## ORIGINATION FORM

Proposed Revisions to a Standard Plans Index  
(Please provide all information — Incomplete forms will be returned)

Index Number: 102-602  
Sheet Number (s): 1 of 2  
Index Title: Two-Lane and Multilane, Work on Shoulder

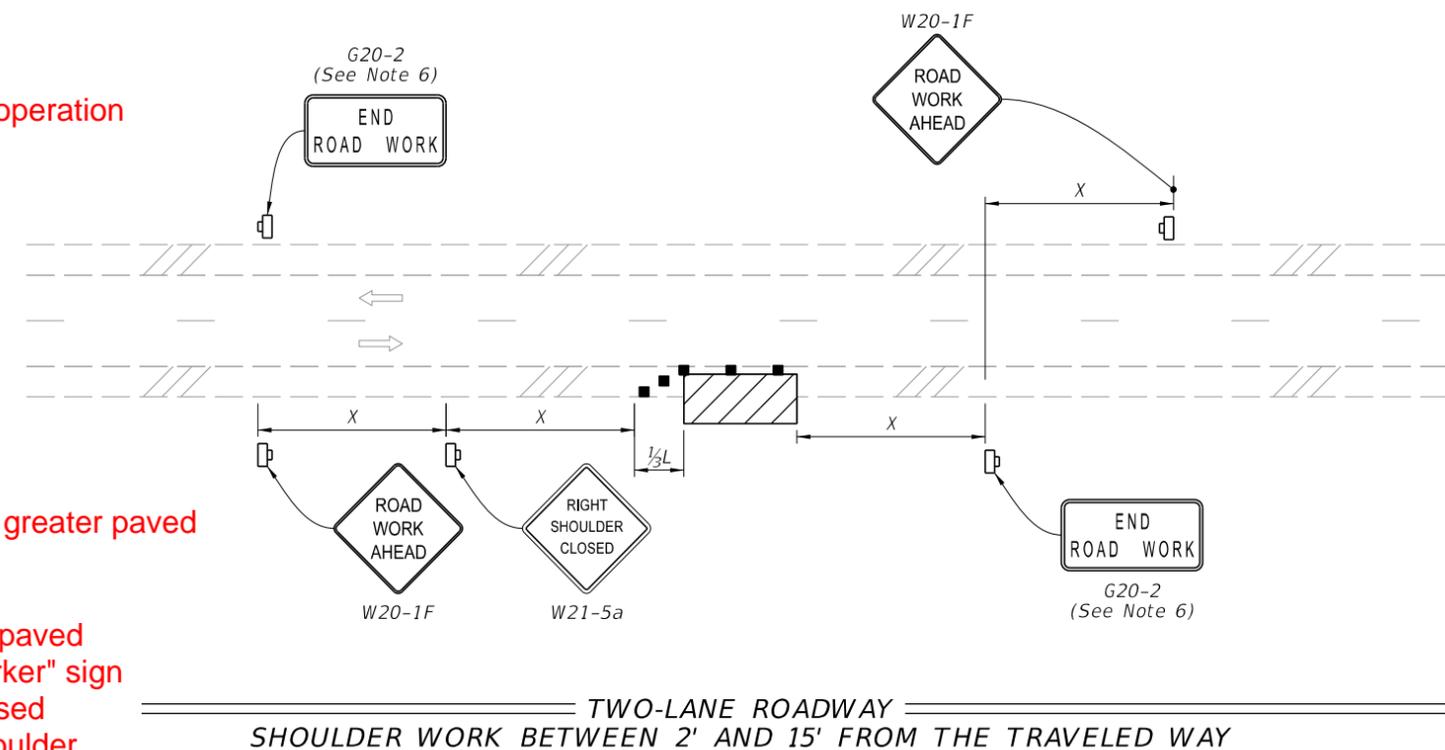
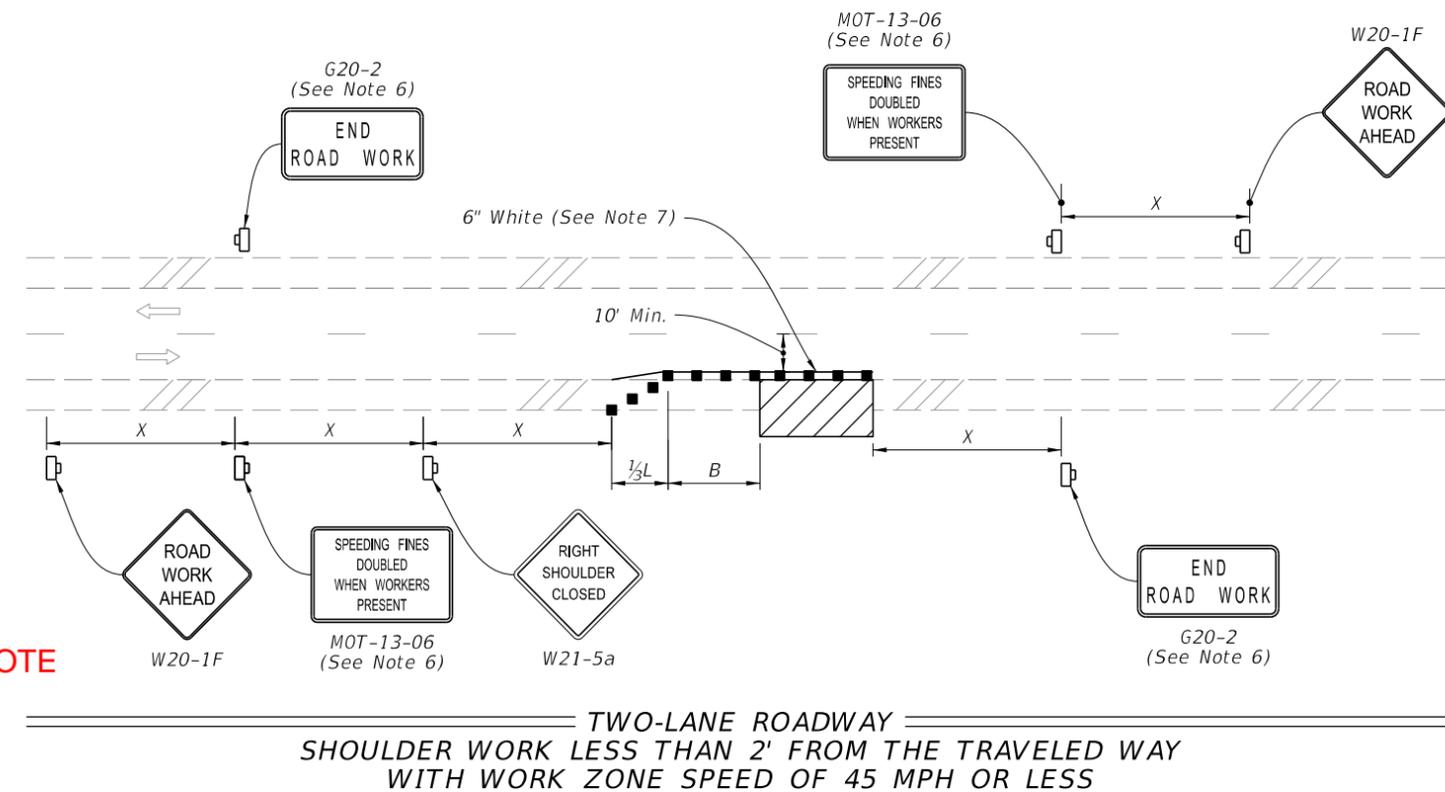
**ADDED: Note 10**  
 When there is no paved shoulder, the "Worker" sign (W21-1) may be used instead of the "Shoulder Closed" sign (W21-5a).

**UPDATED NOTE**

**CHANGED TO: work operation**

**CHANGED TO: operation**

**CHANGED TO: 4' or greater paved**

LAST REVISION 11/01/21	REVISION	DESCRIPTION:	 FY 2022-23 STANDARD PLANS	TWO-LANE AND MULTILANE, WORK ON SHOULDER	INDEX 102-602	SHEET 1 of 2
---------------------------	----------	--------------	--	--	------------------	-----------------

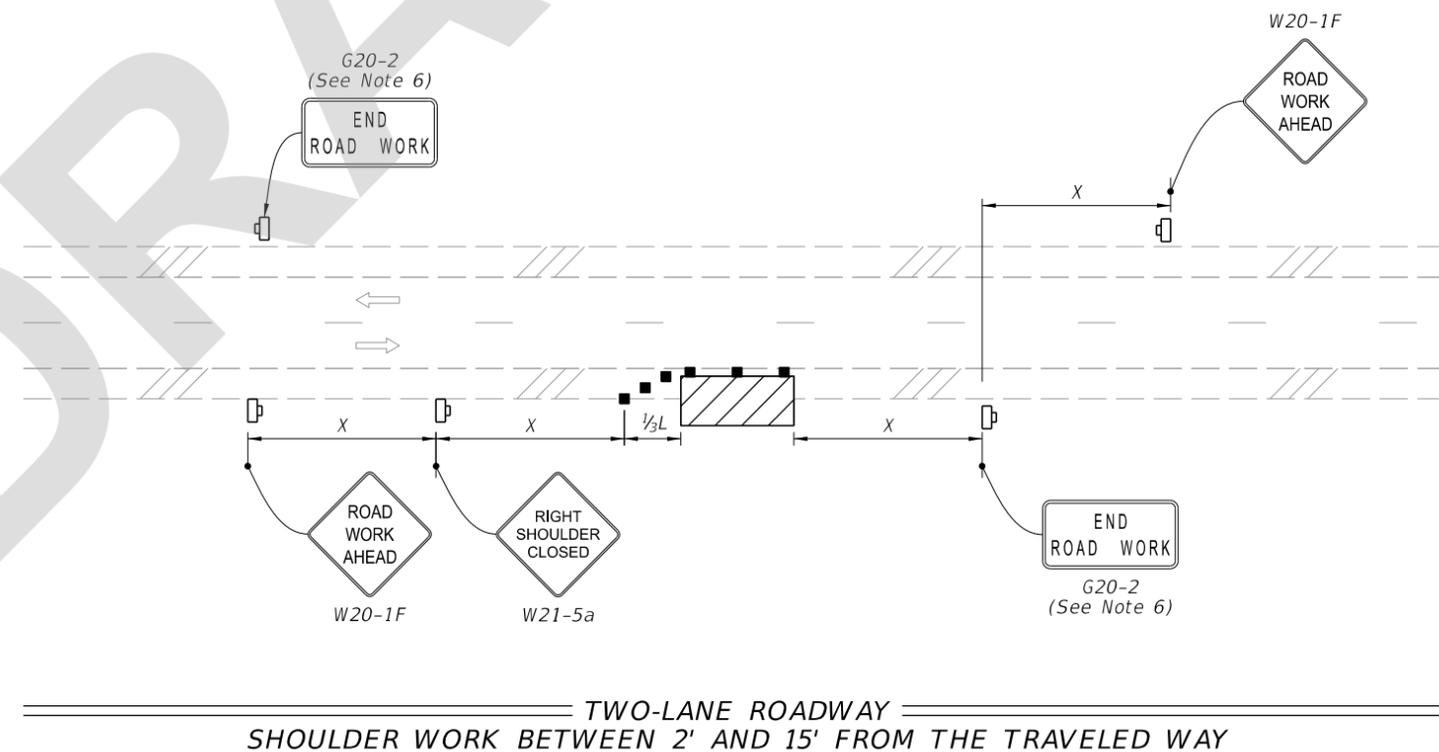
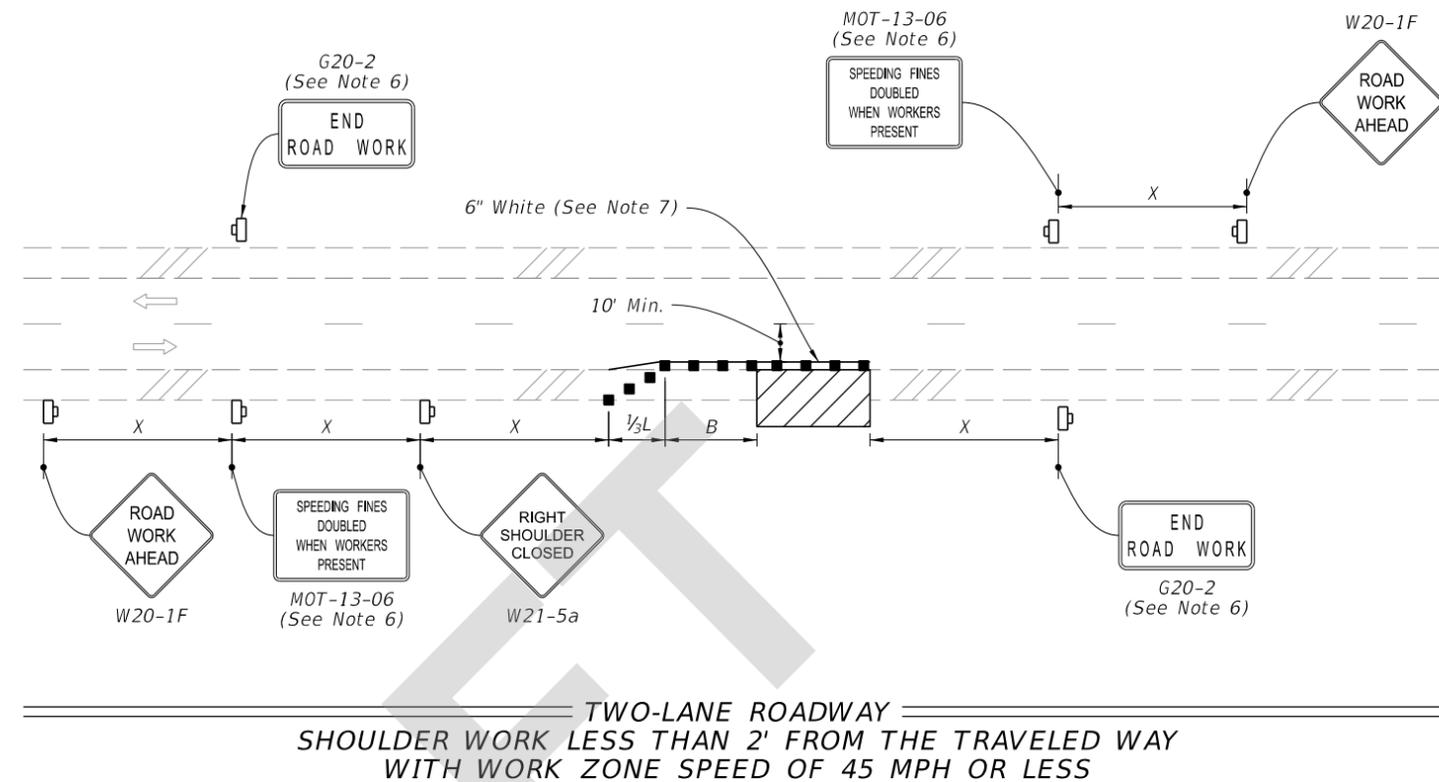
Sheet 1: Updated Note 3 to "Where work activities are between 2' and 15' from the edge of traveled way, the Engineer may omit signs and channelizing devices for work operations 60 minutes or less"; Changed Note 8 - "ridable shoulder" to "4' or greater paved Shoulder"; Added Note 10 "When there is no paved shoulder, the "Workers" sign (W21-1) may be used instead of the "Shoulder Closed" sign (W21-5a)."

3. Where work activities are between 2' and 15' from the edge of traveled way, the Engineer may omit signs and channelizing devices for work operations 60 minutes or less.

7. Temporary pavement markings may be omitted when the work operation is in place for 3 days or less.
8. If the work encroaches on a marked bicycle lane or 4' or greater paved shoulder, close the lane or shoulder in accordance with the Plans.

9. Omit "Shoulder Closed" signs (W21-5a) along with associated work zone sign spacing distances for work on the median.
10. When there is no paved shoulder, the "Worker" sign (W21-1) may be used instead of the "Shoulder Closed" sign (W21-5a).
